**‘SAVE HARDY’S VALE’ COMMUNITY GROUP - PROPOSED SOLAR GENERATING ARRAYS ON
LAND AT NORTH DAIRY FARM, PULHAM DT2 7EA**

Full Planning Application [P/FUL/2021/01018](https://www.gov.uk/government/uploads/system/uploads/attachment_data/file/94424/P_FUL_2021_01018.pdf)

SHV MEMORANDUM - IMPORTANT MATERIAL PLANNING MATTERS

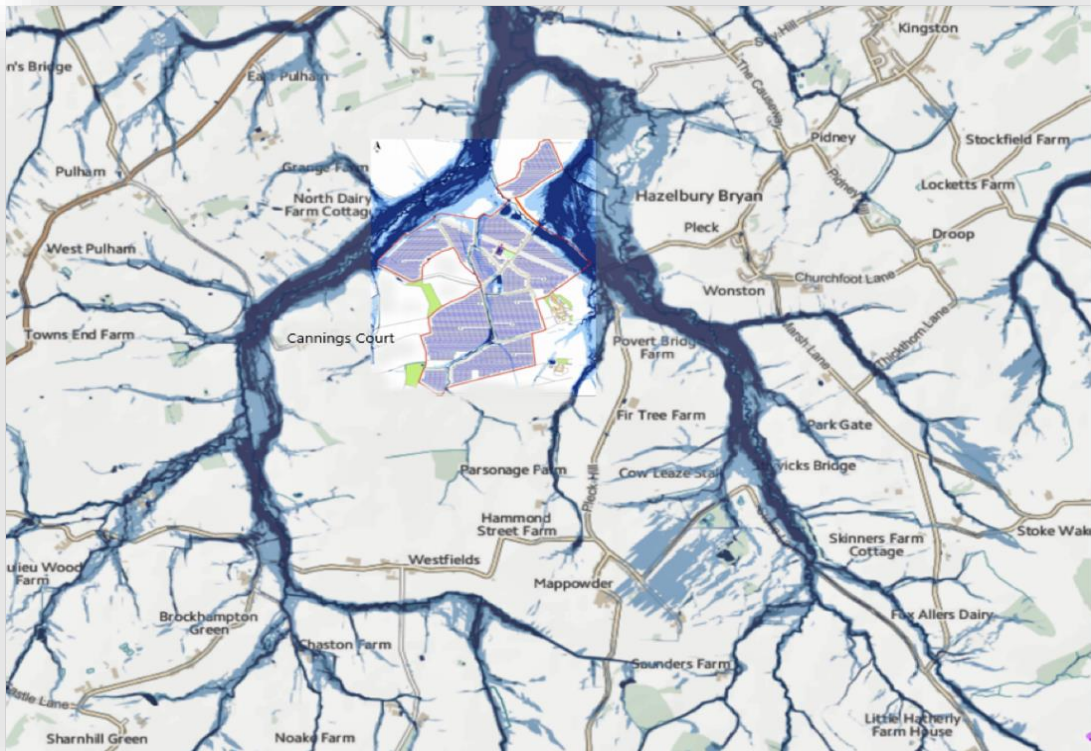
30. The Environment Agency Flood Extent Map (Above) shows the proposed North Dairy Farm development, edged in red. The landscape, to the south below the escarpments, is shaped by very high levels of rainfall, up to 1400 mm a year. That is about three times the rainfall onto the Dorset coastal wards, which many Planning Committee Members represent. Around half of that rainfall rapidly discharges from the Downs and high ground, often flash flooding into the 40 k² Upper Lydden and Wonston Brook Catchment Areas. The two catchments close in and flow around the proposed Site, combining just 90 metres to the north of it, and eventually into the river Stour. Rainfall at the site is estimated to be 984 mm a year. The frequency of extreme weather and rainfall events in the area is significantly increasing. The ground is saturated for 199 days a year and has very low infiltration rates.

31. The Applicant's Flood Risk Assessment states **“It has been demonstrated that the access route could flood to a depth of 1 metre. The hazard rating for this is defined as a danger for the general public including the emergency services” which could prohibit safe Site access and egress by the only road into the Site.**
